ARAPAHO ROAD PHASE III
 PLAN & PROFILE
STORM SEWER 'C' STA. 0+00 TO STA. 5+00
TOWN OF ADDISON

g&a Grantham & Associates, Inc. SHT. SW-17

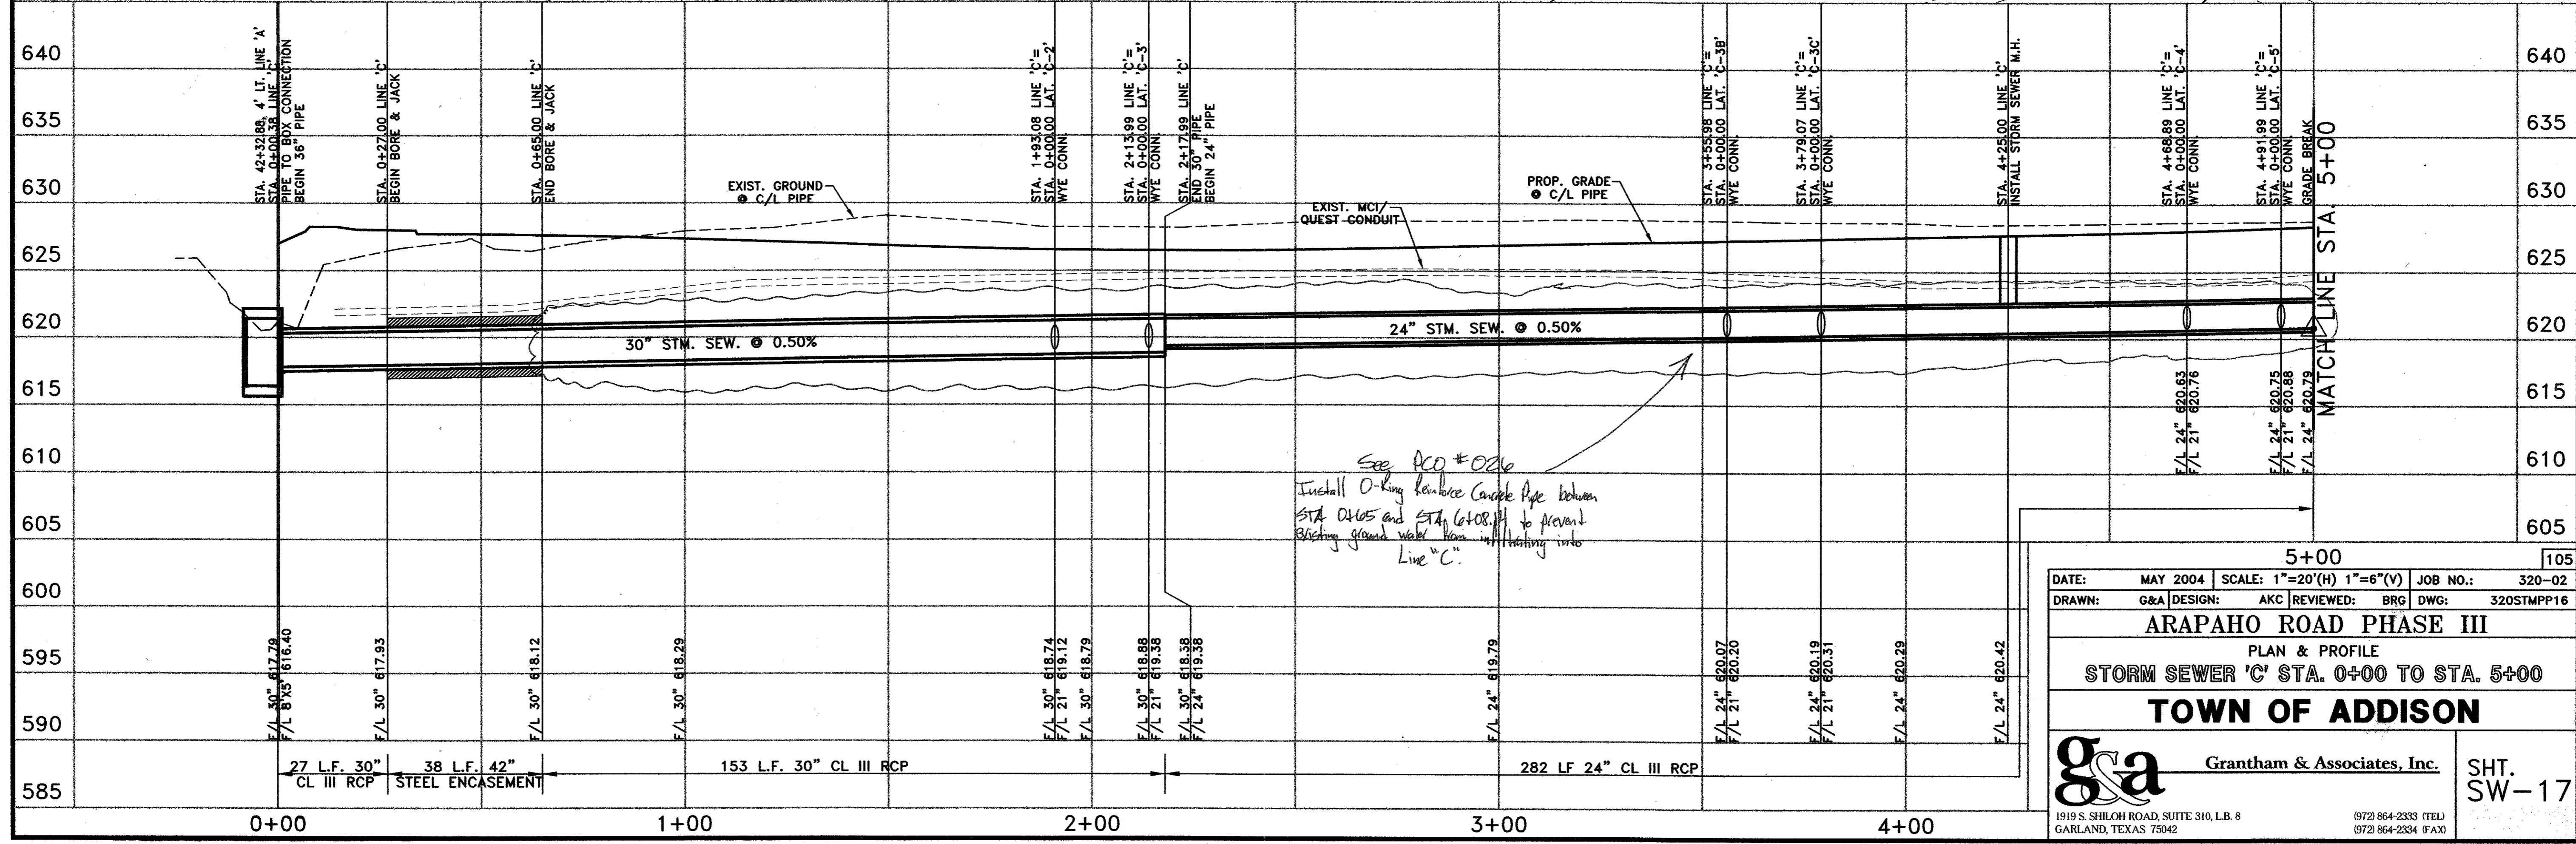
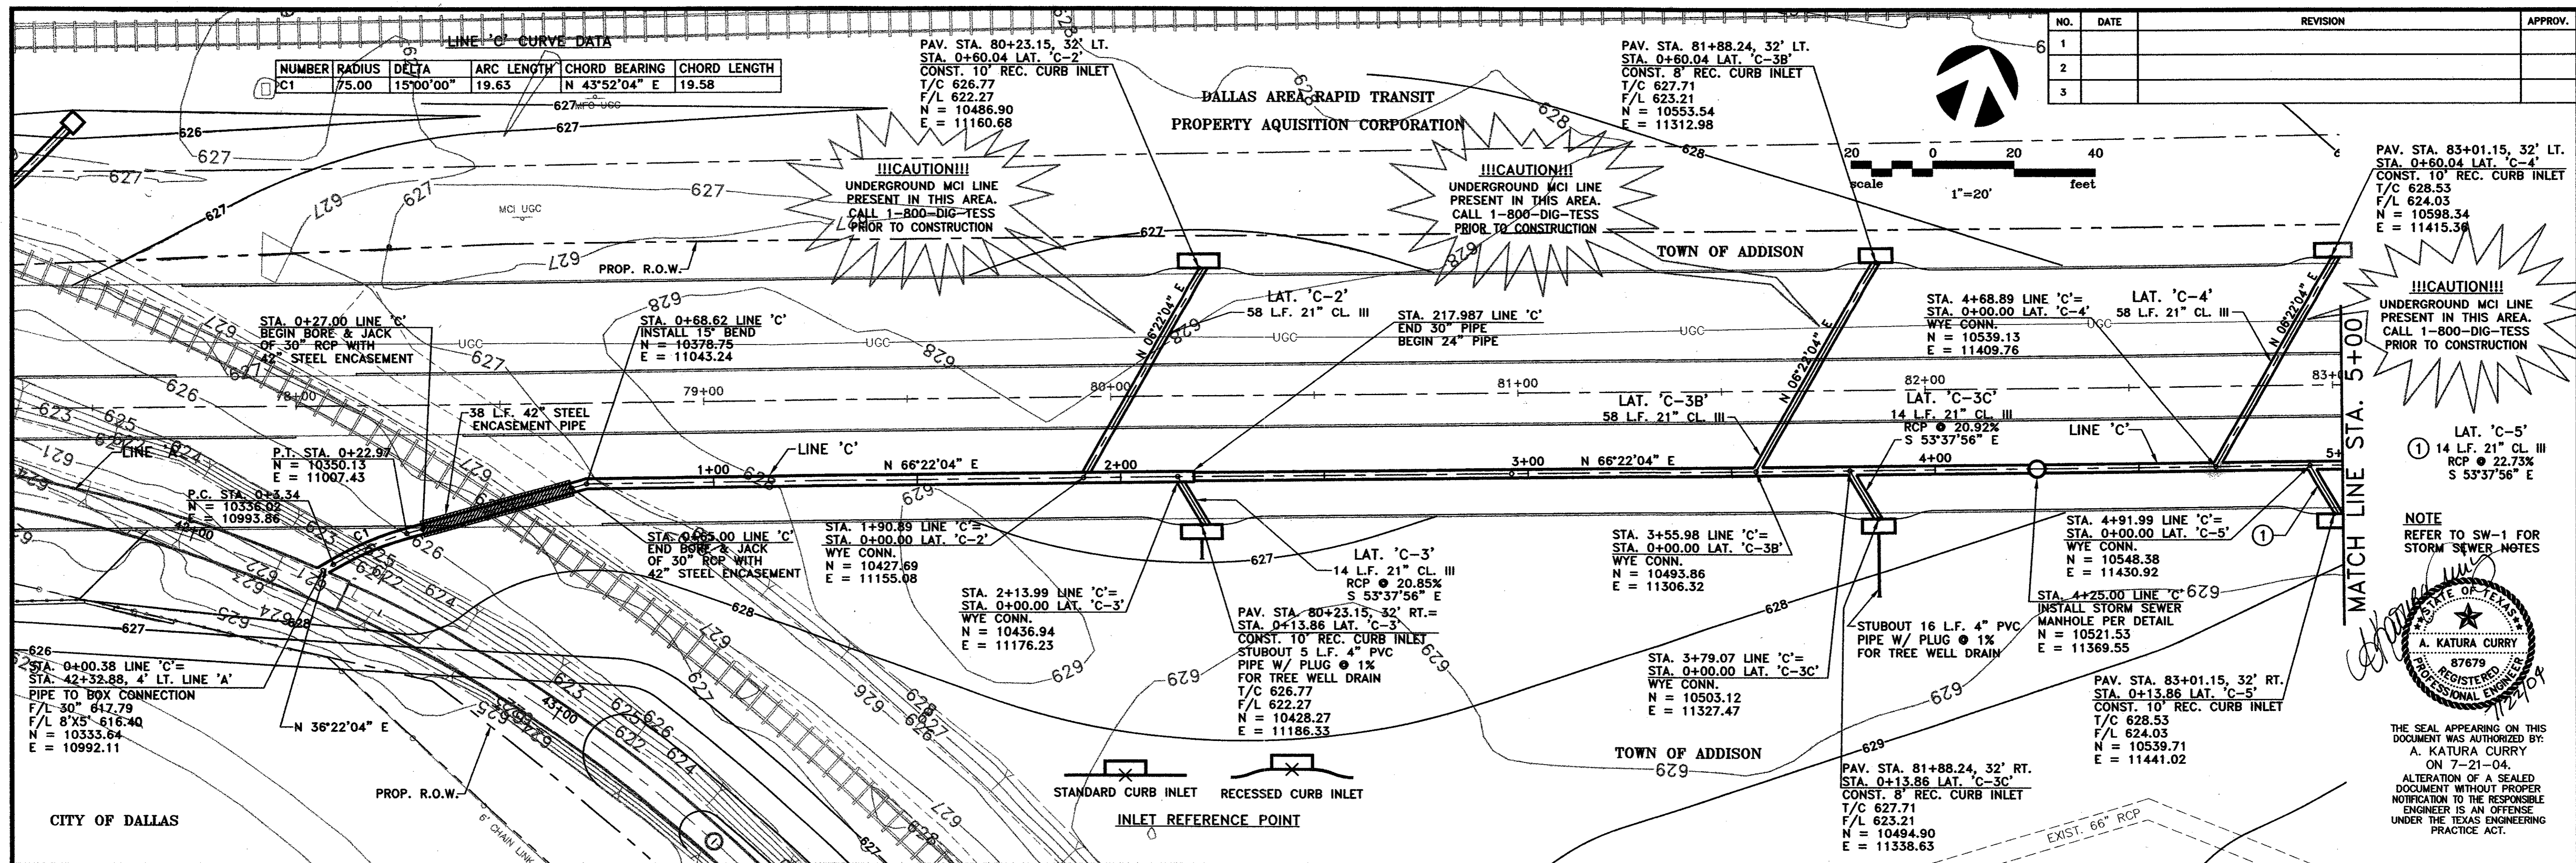
See ACO #026
Install O-ring Reinforced Concrete Pipe between STA. 0+105 and STA. 0+108.11 to prevent backing ground water from infiltrating into Line "C".
